BMP NUMBER: WC072

**James City County Environmental Division
Stormwater Management/BMP Record Drawing &
Construction Certification Review
Tracking Form**

Project Name: Storehouse Bent Tree sec 5B Ph 3
County Plan No.: 6-81-99 S-68-01
Stormwater Management Facility: BMP # 5.4 Dry Pond
BMP Phase #: I II III
 Information Package Received. Date/By: 10/12/04 AES

Project Name: Stonehouse - Section V-B (Bent Tree Phase 3)
Structure/BMP Name: BMP #5.4
Project Location: Stonehouse - Bent Tree
BMP Location: Off Private Drive at end of Sapling Drive
County Plan No.: JCC Case No. S - 81 - 99

Designed RGW	Drawn RED
Scale NOTED	Date 3/2/01
Project No. 8878-00	
Drawing No. R17

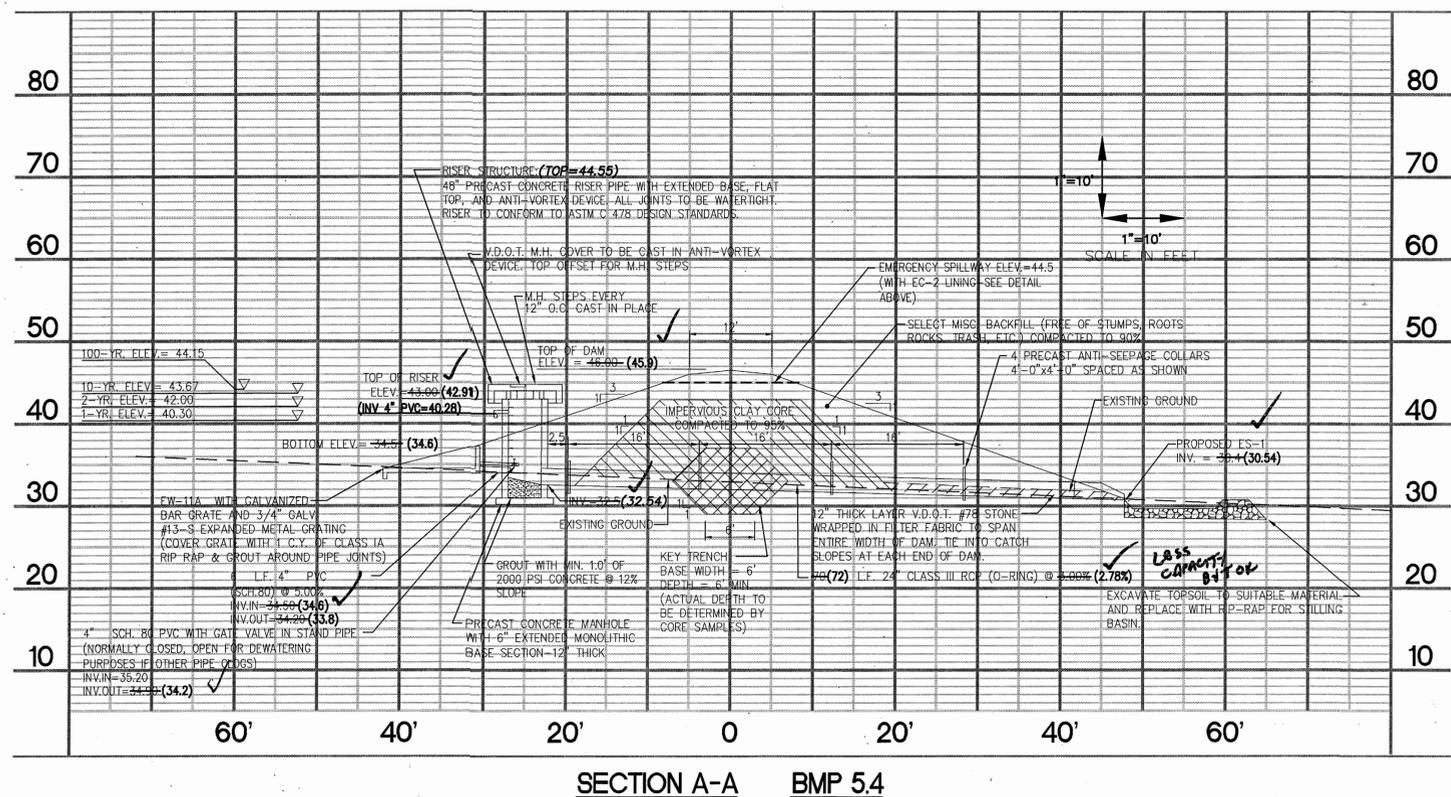
28. BMP Design. Explain the purpose of the 4-inch PVC gate valve at the end of the low-flow orifice if basin design is intended as dry extended detention. If the valve is necessary, indicate "normally open" on the detail on Sheet 17.

DESIGNED: VMB/JAG
 DRAWN: JAG
 SCALE: 1" = 50'
 DATE: 3/5/02
 PROJECT NO.: 8878-00
 DRAWING NO.: 13 A

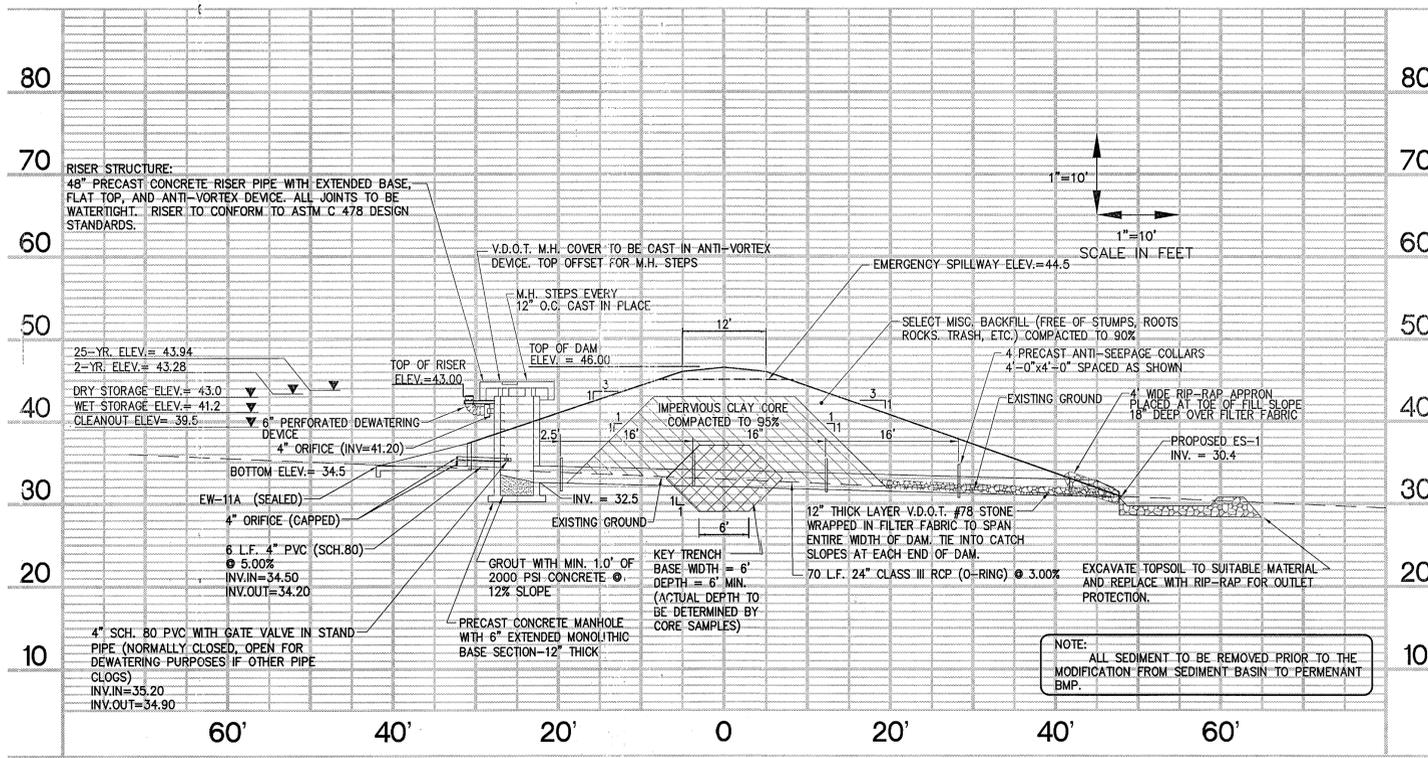
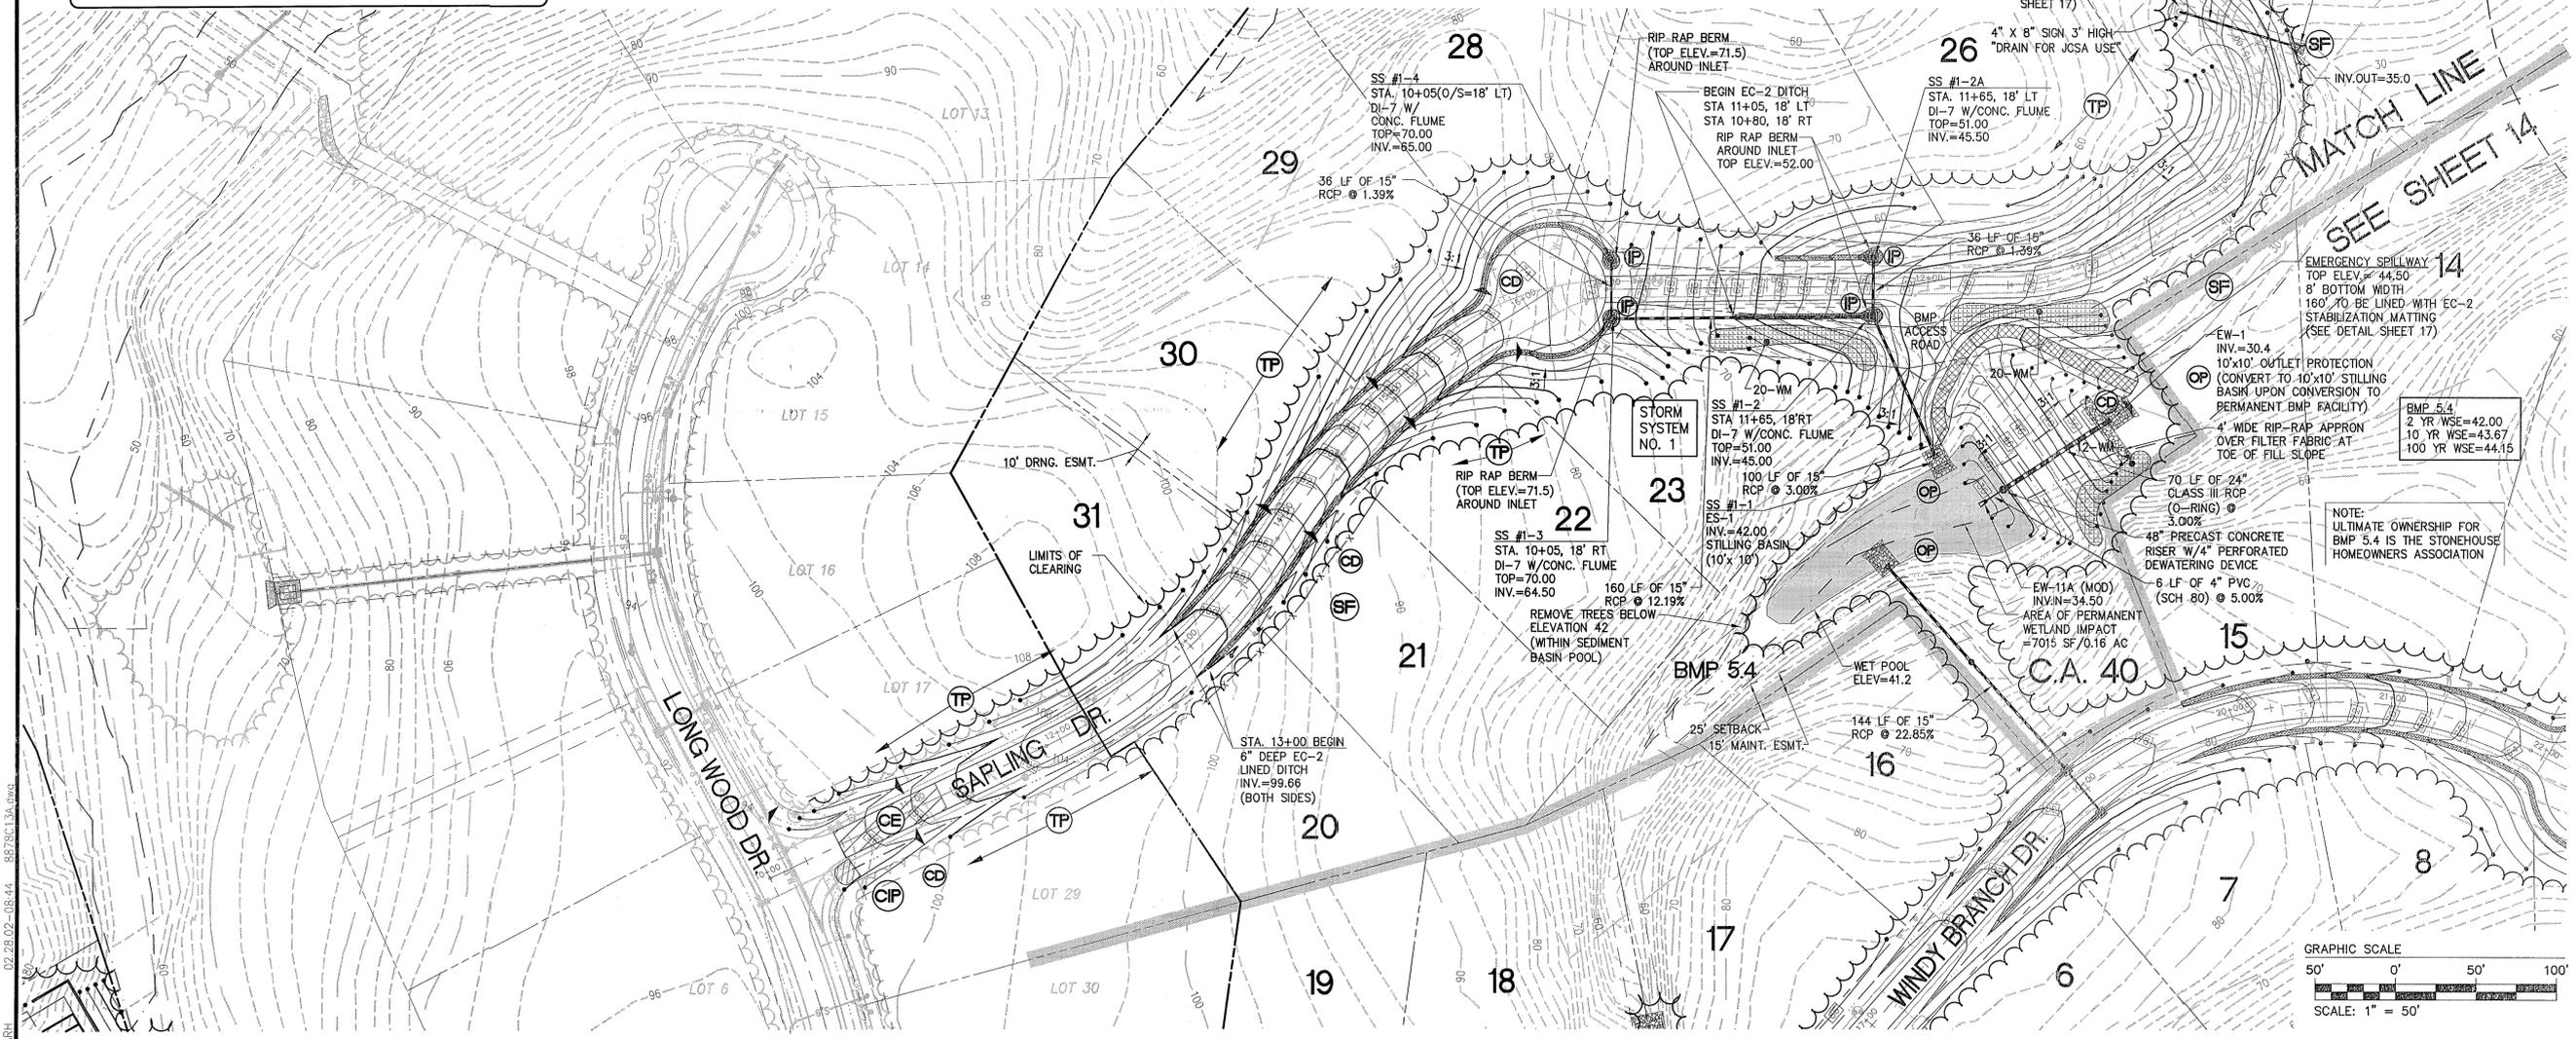
15. Grading Plan. Label intended cut/fill slopes on plan Sheets 13, 14 and 15 to the greatest extent possible (3H:1V, 2H:1V, etc.). Use standard VESCH Chapter 3 symbols to indicate areas where matting is required.

23. Stilling Basins. No dimensions were found on Sheets 13 & 14 for stilling basins proposed at SS # 1-1, SS # 2-1, SS # 3-1, SS # 4-1 and at BMP # 5.4. Also, some side walls of the basins are shown at 1H:1V (ie. slope down areas). The detail on Sheet 19 should reflect slopes for the basins at 2H:1V maximum per Minimum Standard 3.18 of the VESCH. Also indicate slope required (3H:1V, etc.) above the upper limit of riprap, if additional cut is required to tie/meet original ground.

PURPOSE AND INTENT OF AMENDED PLAN SHEET 13A IS TO SHOW THE REDESIGN OF BMP 5.4 INTO A SEDIMENT BASIN. THIS WILL ELIMINATE THE NEED FOR THE UPHILL SEDIMENT TRAP PREVENTING EXCESSIVE CLEARING AND GRADING ACTIVITIES ON STEEP SLOPES.
